Joint Statement between Lancashire County Council and the Ministry of Justice

Land adjacent to HMP Garth and HMP Wymott, Ulnes Walton, Leyland

Appeal ref. APP/D2320/W/22/3295556

**Road Safety Audit
Stage 1 - Completion of Preliminary Design**

Drawing Title
**PROPOSED MITIGATION WORKS
ULNES WALTON LANE / A581
PROPOSED MINI ROUNDABOUT**

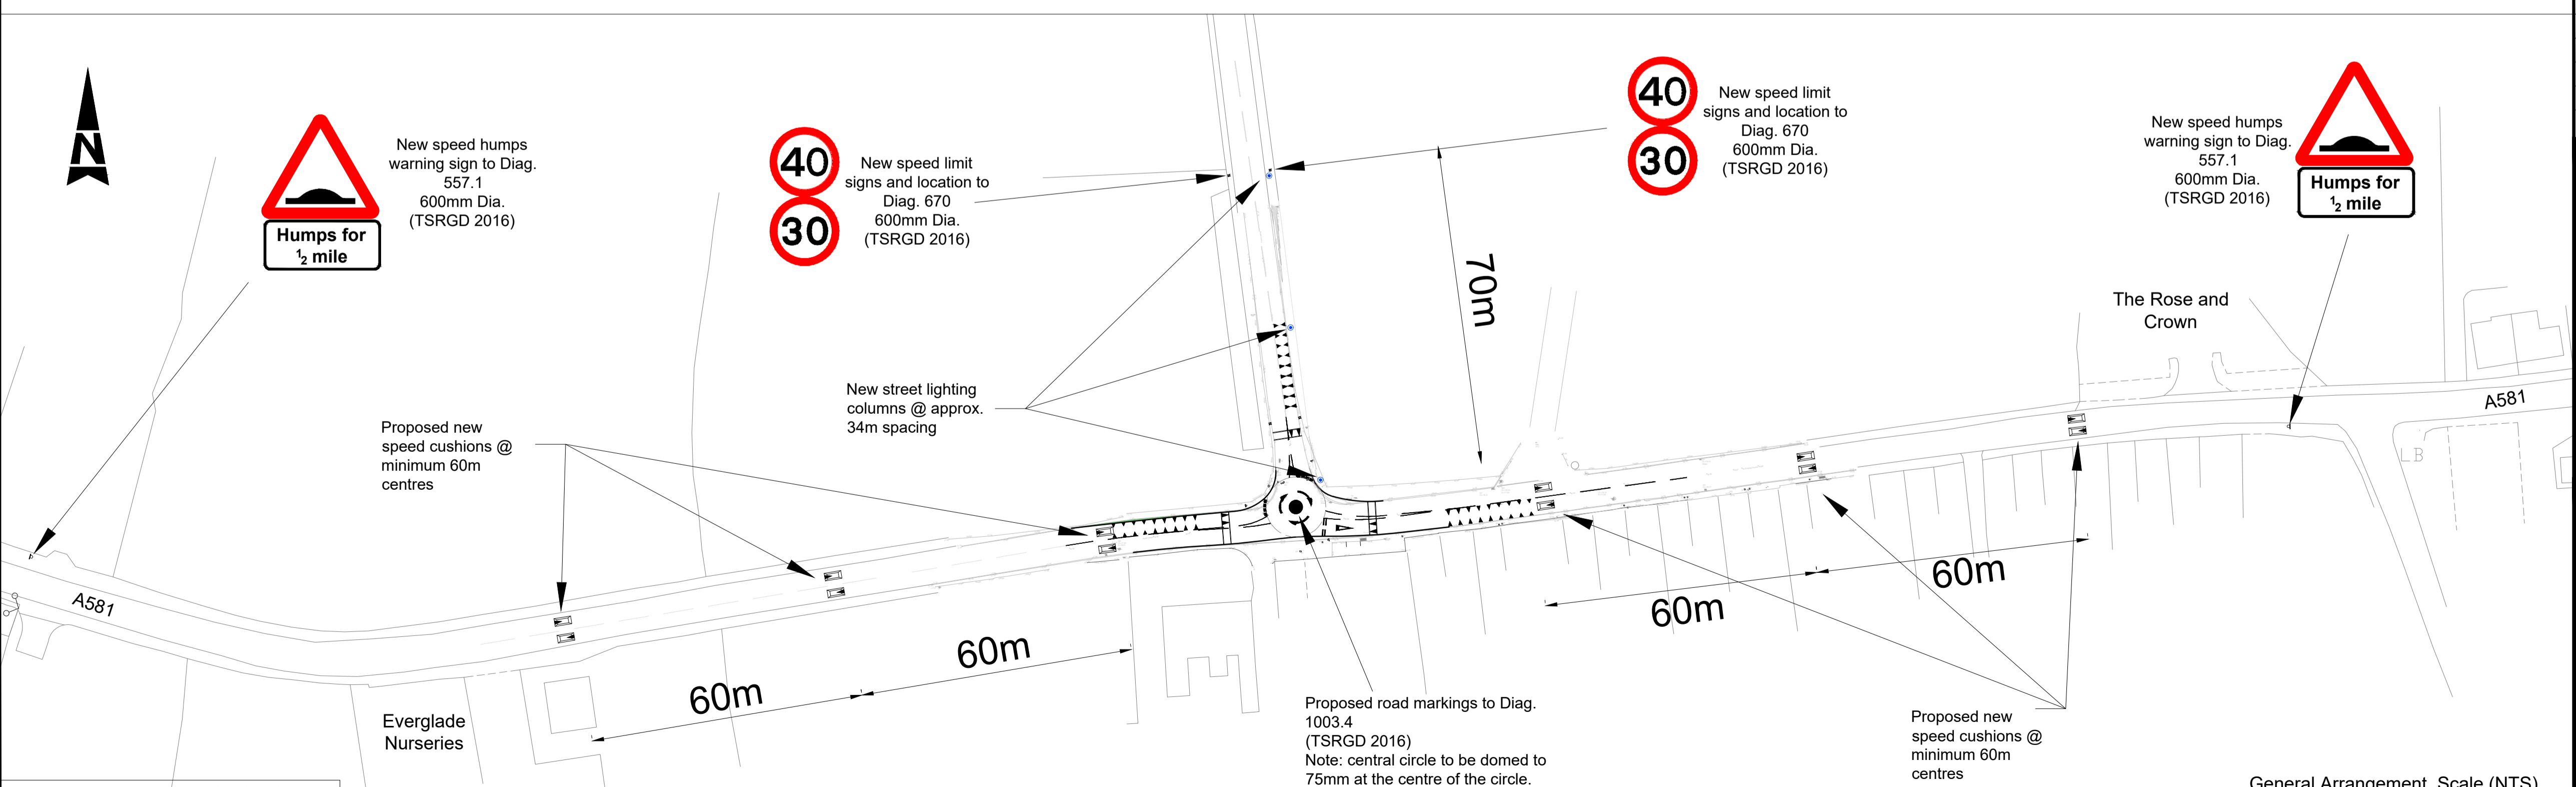
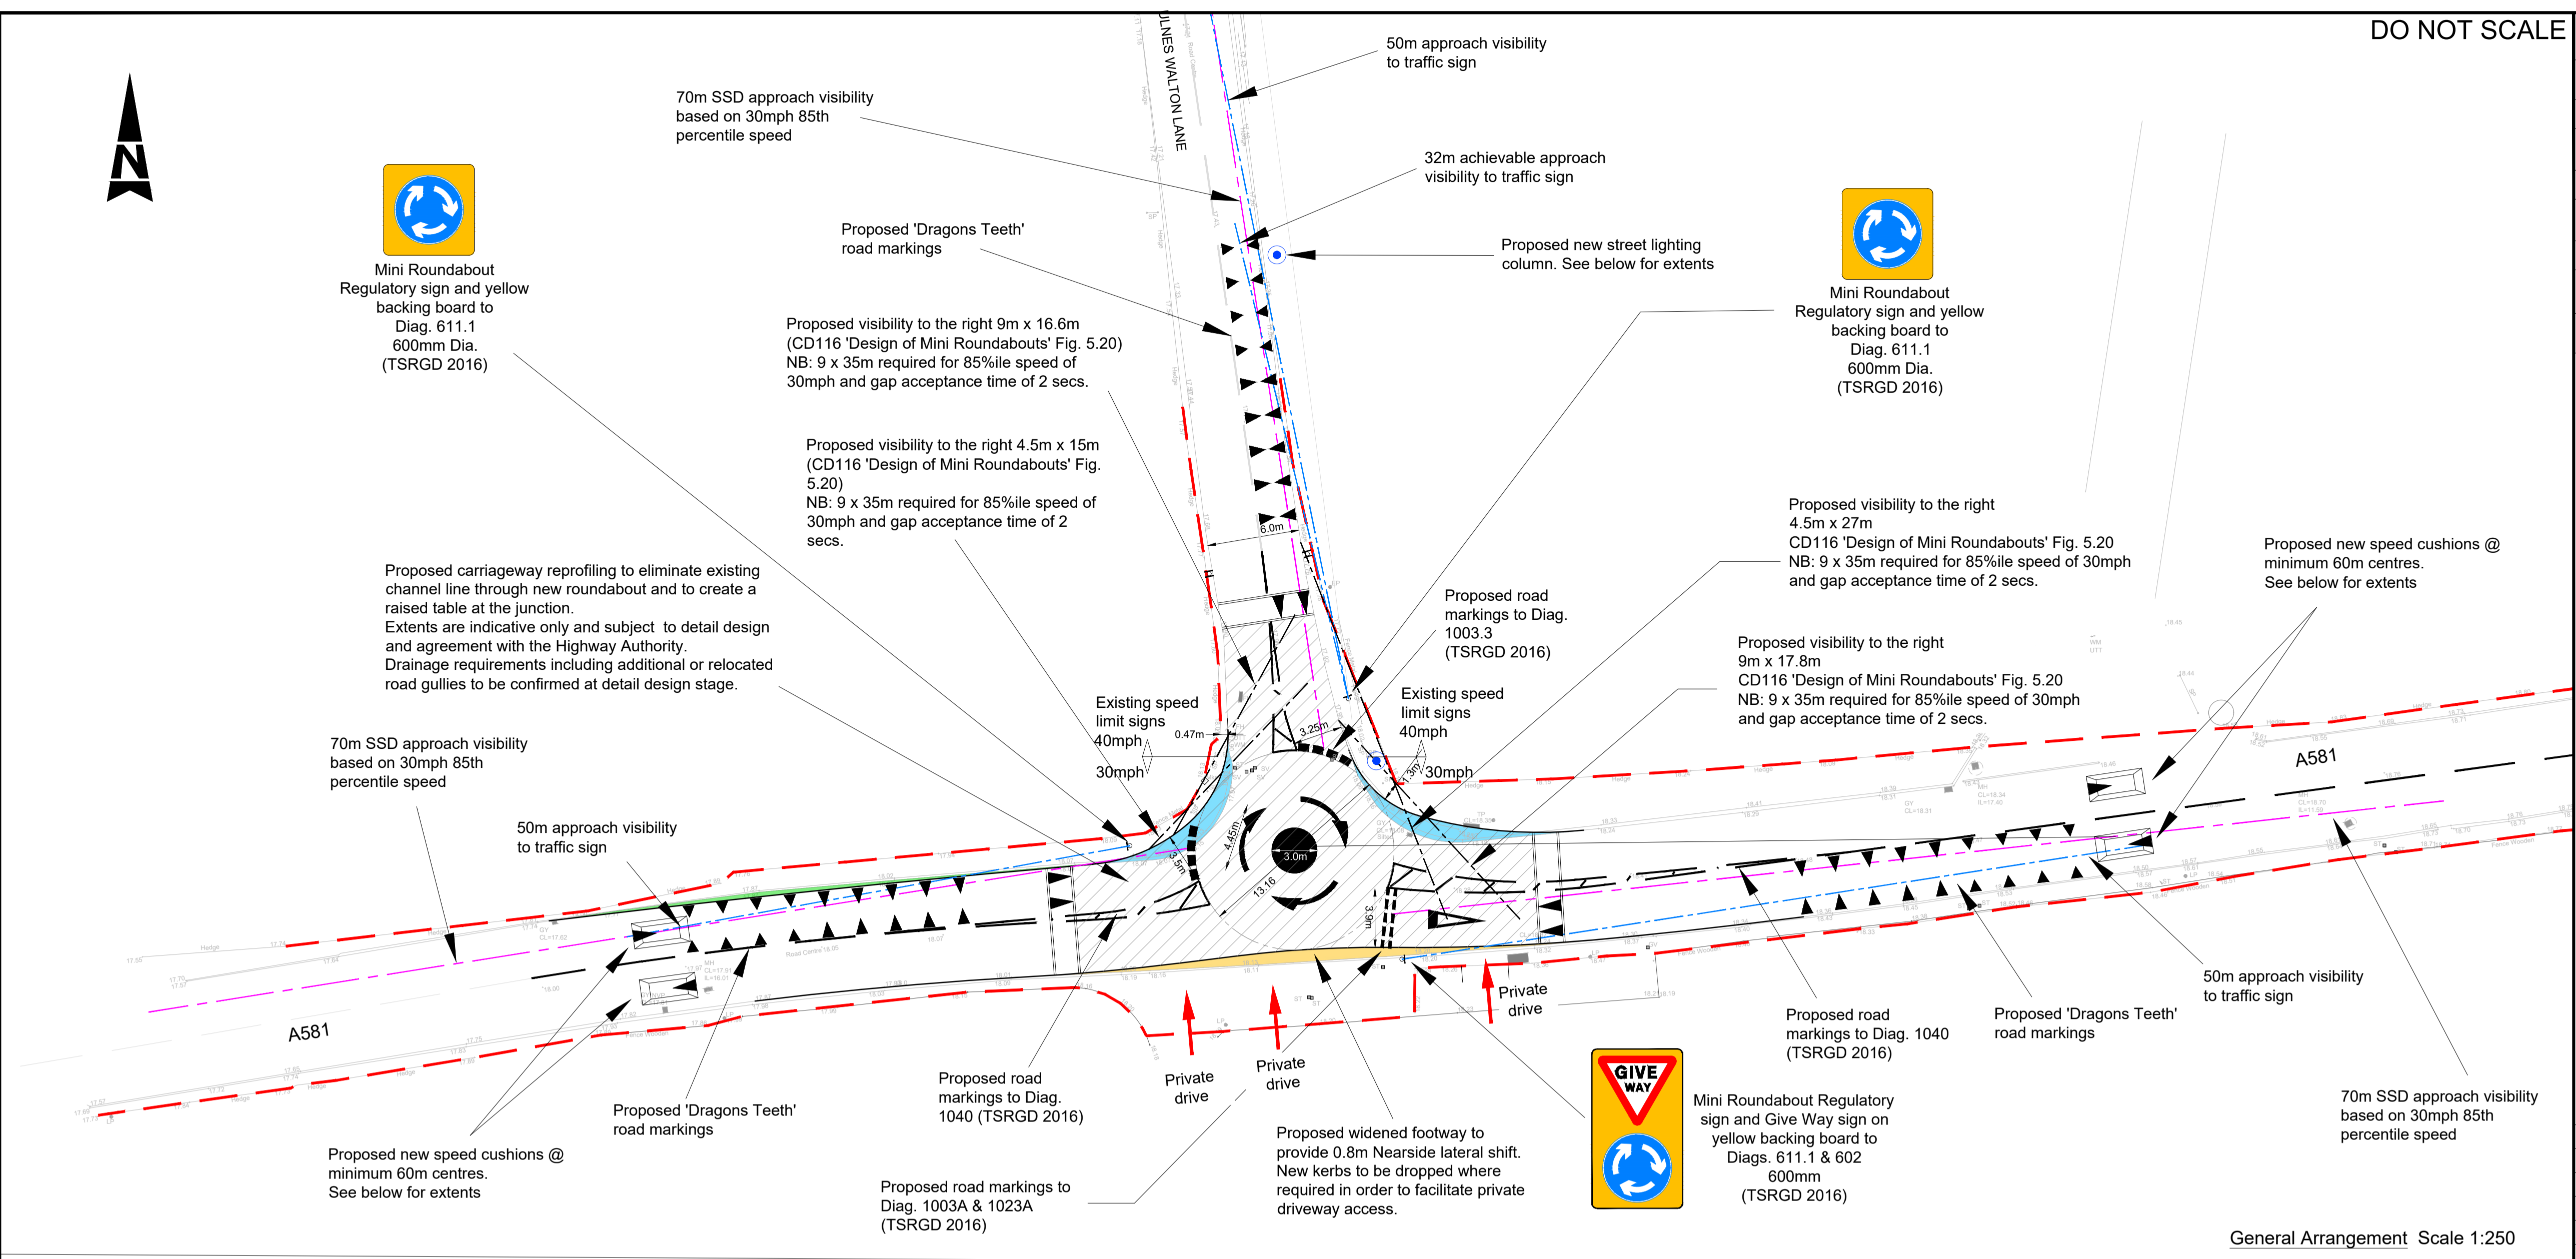
It was observed on site that a partial improvement in the view to the right could be obtained by looking through the boundary fence. However this additional visibility could be removed if the landowner were to replace the relatively open fence with a hedge, or plant crops, for example. Junction visibility should therefore only be measured across land within the Highway Authority's control, and we note that this is the approach wisely taken by the current design. Unfortunately the view obtained may be insufficient.

particular risk of injury. The layout shown in the design appears to show the cushions in the centre of the existing running lanes, which can lead to this type of problem.

The Stage 1 RSA has recommended that an alternative junction solution is provided at the A581/Ulnes Walton Lane junction. The RSA recommendation is not agreed. The following sections provide a response to this recommendation.

The introduction of a mini roundabout at the A581/Ulnes Walton Lane junction was in response to the standalone junction capacity assessment contained within Section 7.3.6 of the Transport Assessment (TA) for HMP Garth Wymott 2 (Appeal Core Document A35). The A581/Ulnes Walton Lane junction is forecast to operate over acceptable thresholds of capacity in the AM Peak during the '2025 Opening Year without Development' scenario with a maximum RFC¹ of 0.90. The additional traffic generated by the development proposals increase the RFC in the AM Peak to 1.10 in the '2025 Opening Year with Development' scenario.

Atkins Summary Response: The proposed form of junction has been selected to address the specific capacity concerns raised by the standalone junction capacity analysis.

Atkins Summary Response: The proposed highway layout provides an improvement on the existing highway layout for Articulated HGVs turning left out of Ulnes Walton Lane.

Atkins Summary Response: Good Practice Guidance from the DfT states that mini roundabouts can provide safety benefits over other forms of junction, and they have a lower severity rate.
